Access Compliance Report

Public Rights-of-Way

Intersection ID: 53191	Main Street: JOHNSTON_OEHLER_PRIVATE_DR	Cross Street: JOHNSTON_OEHLER_RD	Location: SW
ADA ID: F9B200C4197F	Ramp Type: Directional	Initial Pass/Fail: Pass	Overall Compliance: No
			Severity Score: 0

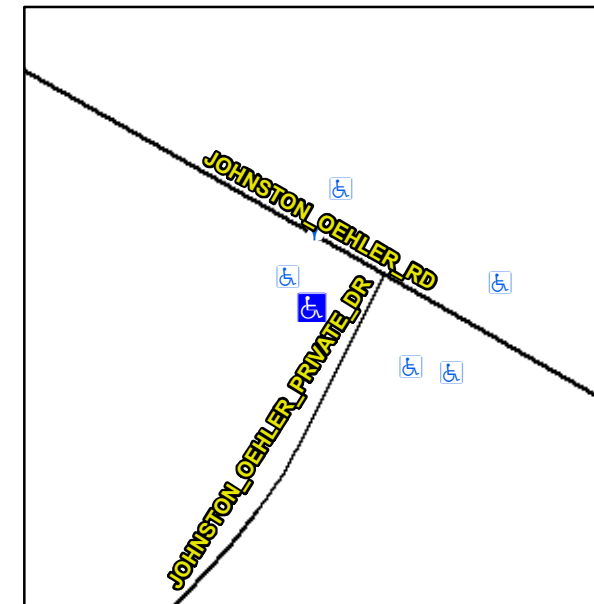
PROW/ADA:

Not Found, R304.5.2

Compliance	Description	Data	Compliance	Description	Data
N/A	Ramp Length (in)	96.0	No	Grade Break?	No
Yes	Ramp Width (in)	69.0	N/A	Grade Break Slope (%)	5.0
Yes	Ramp Slope (%)	6.5	N/A	Grade Break XSlope (%)	2.1
Yes	Ramp XSlope (%)	2.0			
Yes	Flare Type LT	N/A	Yes	Flare Type RT	N/A
N/A	Flare Slope LT (%)	N/A	N/A	Flare Slope RT (%)	N/A
N/A	Flare Traversable LT?	No	N/A	Flare Traversable RT?	No
Yes	Landing Length (in)	73.0	Yes	DWS Provided?	Yes
Yes	Landing Width (in)	69.0	Yes	DWS Contrast?	Yes
Yes	Landing Slope (%)	1.9	Yes	DWS Length (in)	24.0
Yes	Landing X Slope (%)	0.4	Yes	DWS Full Width?	Yes
N/A	Landing Curb? (Y/N)	N/A	Yes	DWS Offset LT (in)	55.0
N/A	Shared Landing?	No	Yes	DWS Offset RT (in)	1.0
Yes	Gutter Ponding?	No	Yes	Gutter Slope (%)	1.9
Yes	Gutter Lip Ht (in)	0.0	Yes	Gutter X Slope (%)	0.2
N/A	Painted X Walk1?	No		Road Slope (%)	0.9
	X Walk 1 Direction	To E		Road X Slope (%)	0.1
	X Walk 1 Width (in)	N/A		Clear Space?	Yes

Possible Solutions:

Remove & Replace Entire Ramp.
